# **ROCKY FLATS ENVIRONMENTAL TECHNOLOGY SITE**

## **771 Closure Project Decommissioning Operations Plan Modification 5**

**August 8, 2003**

## 11 COMMENT RESPONSIVENESS SUMMARY

Figure 4. Building 771 First Floor Plan Demolition Concept

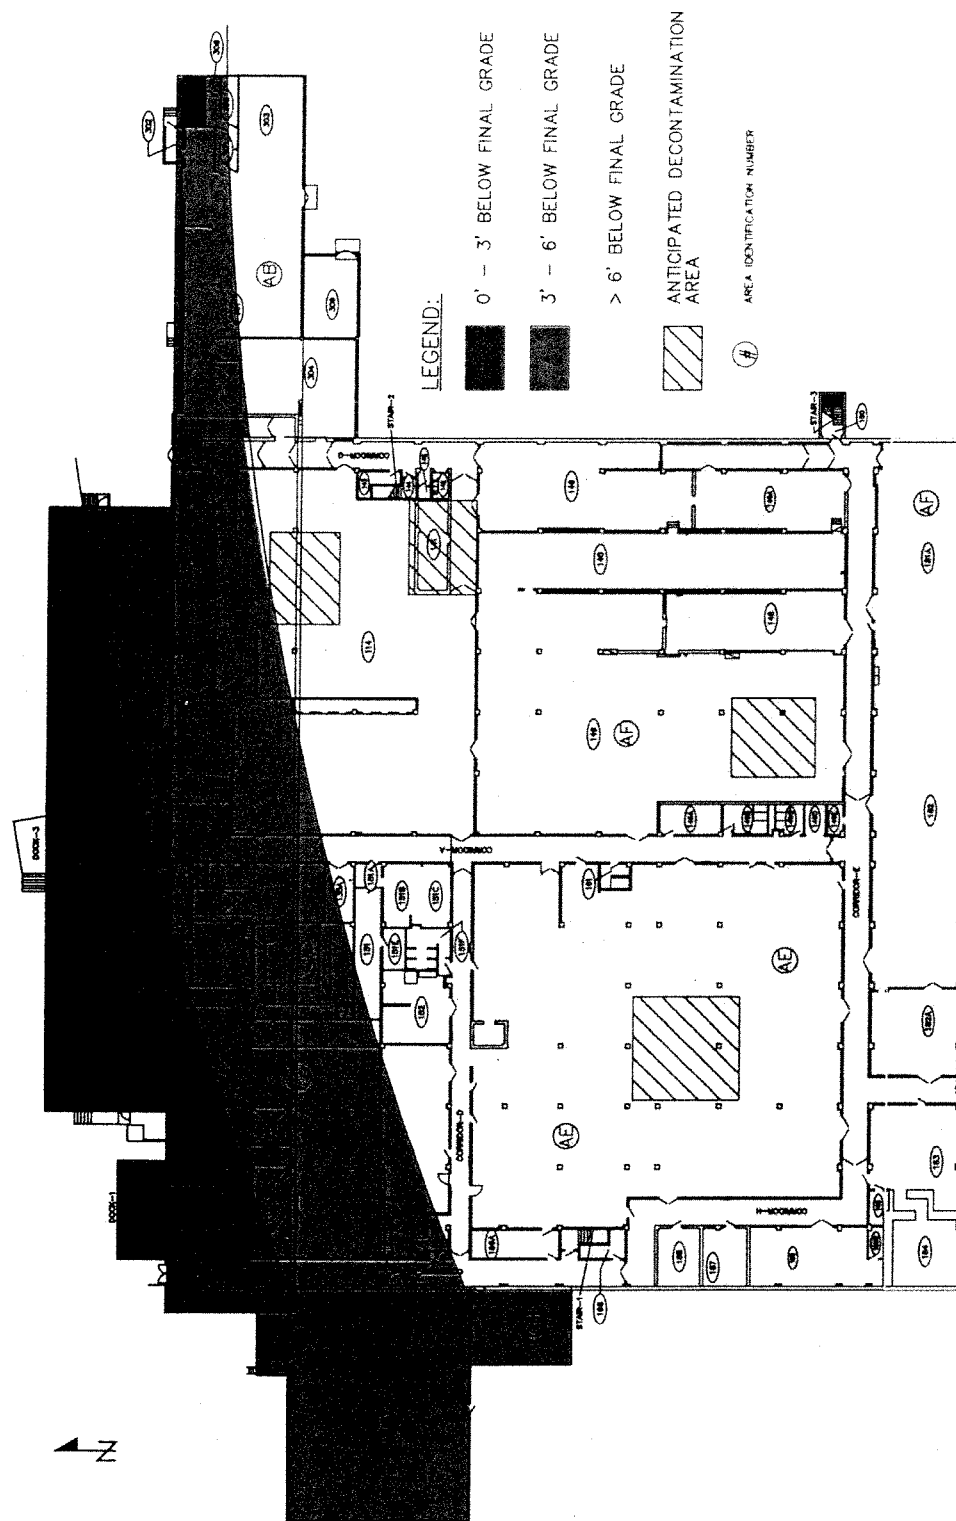
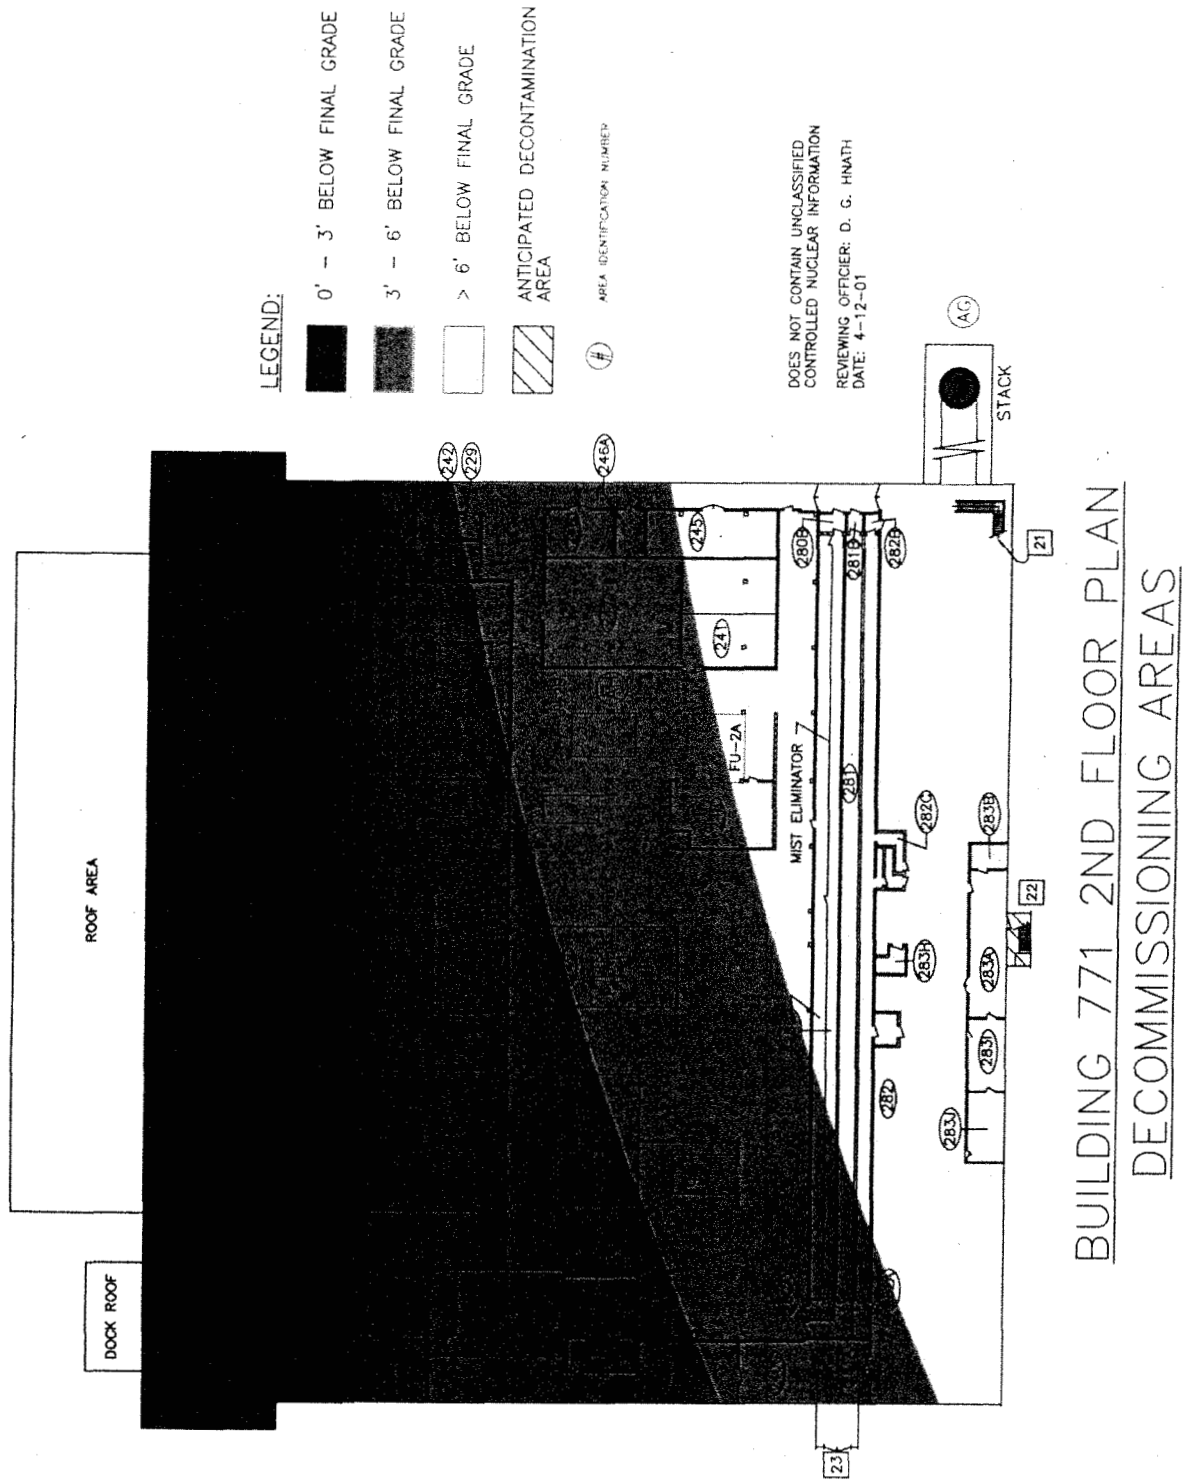
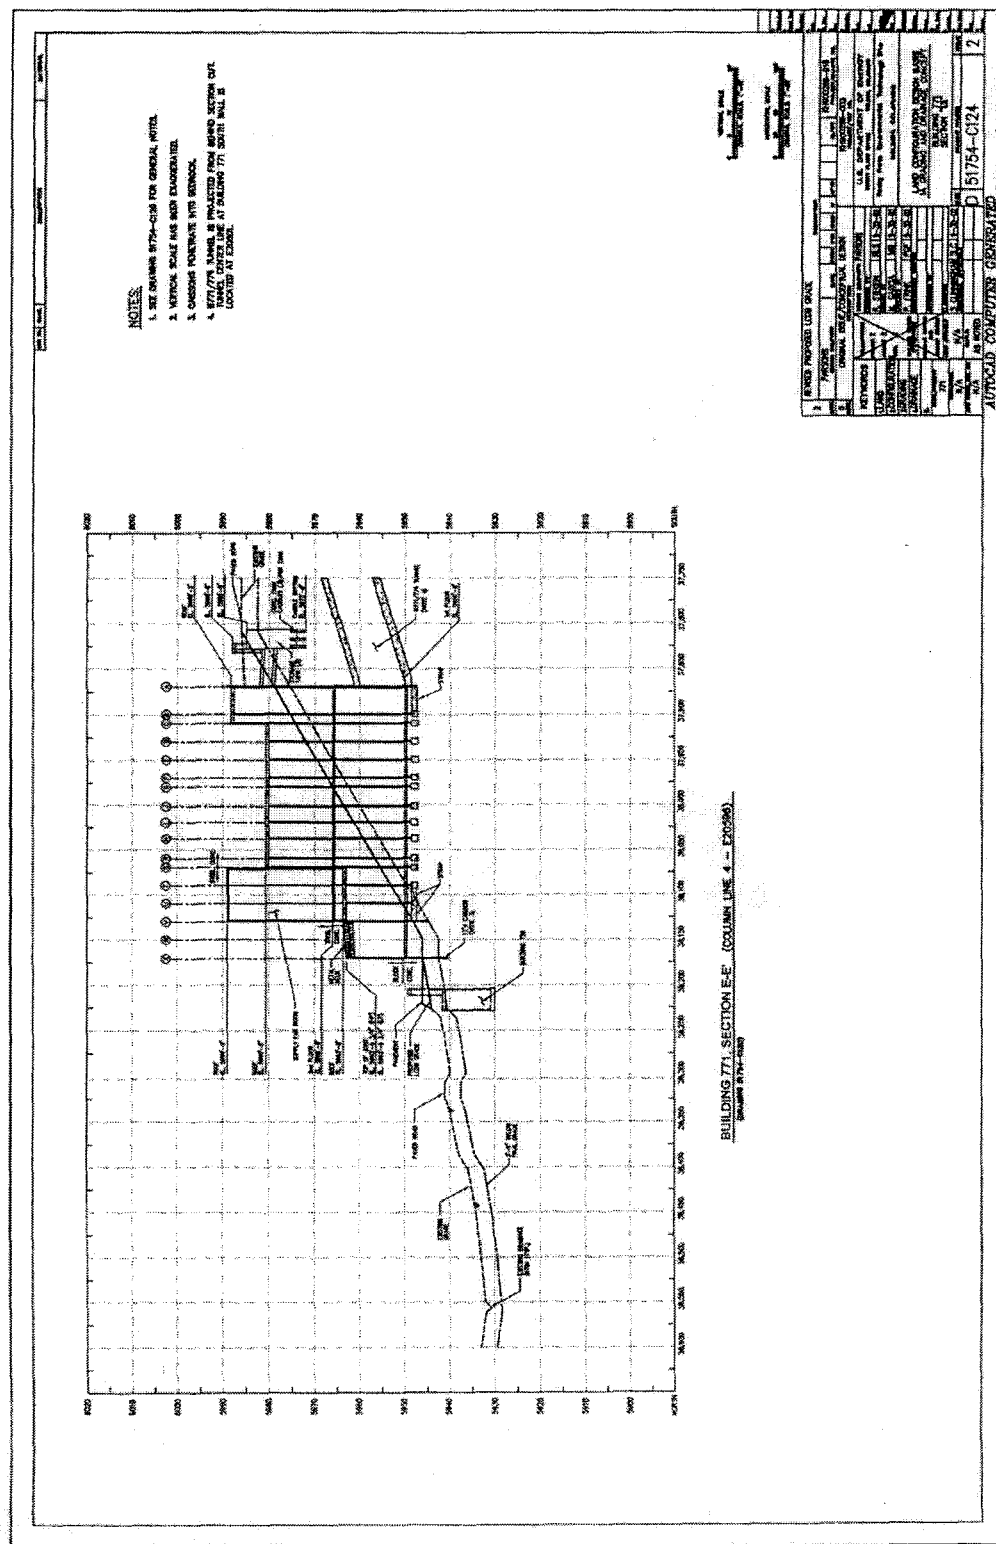
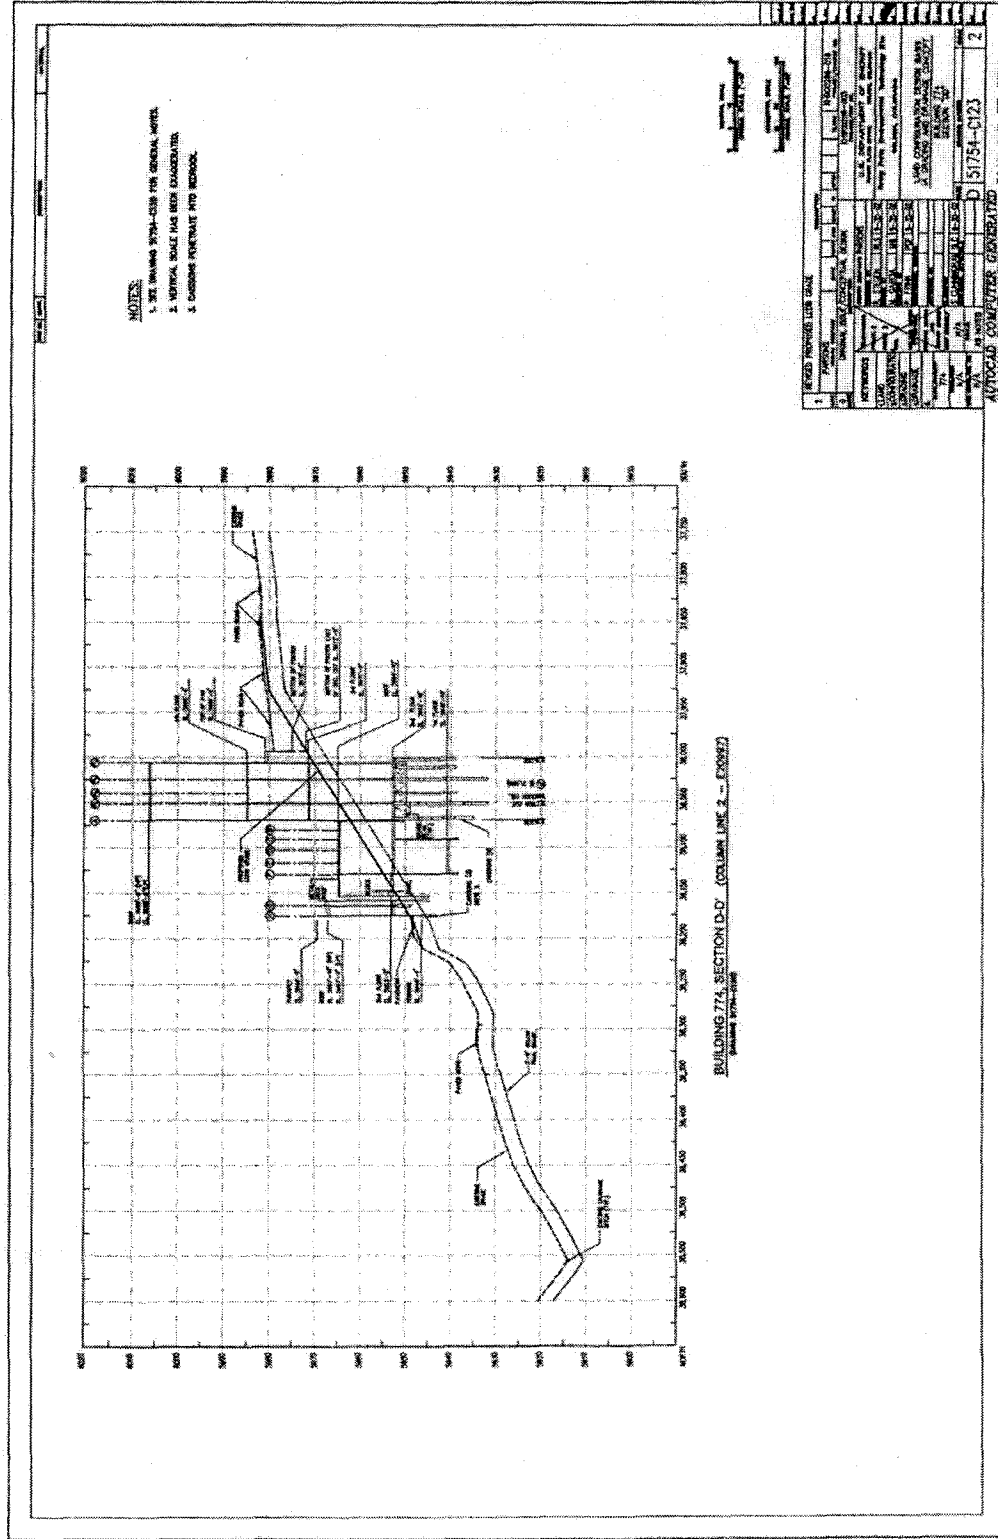
5	<p><b>Figures</b></p> <p>The text in Section 4.7.1.8 (Demolition of the Main Building 771 Structure) describes the planned three-sided configuration for the Building 771 foundation area after demolition, and states that "Figures 4 and 5 provide an aerial view of this concept." Figures 4 and 5 provide a useful aerial view, but they do not show the three-sided configuration referenced. During the Coalition staff briefings, Site representatives distributed side-view diagrams of the post-demolition condition of B771 and B774. It would be helpful to include these diagrams so that the reader has a better understanding of the depth of the buildings and how much of the structures will be demolished.</p>	<p>These figures were added to the document.</p>
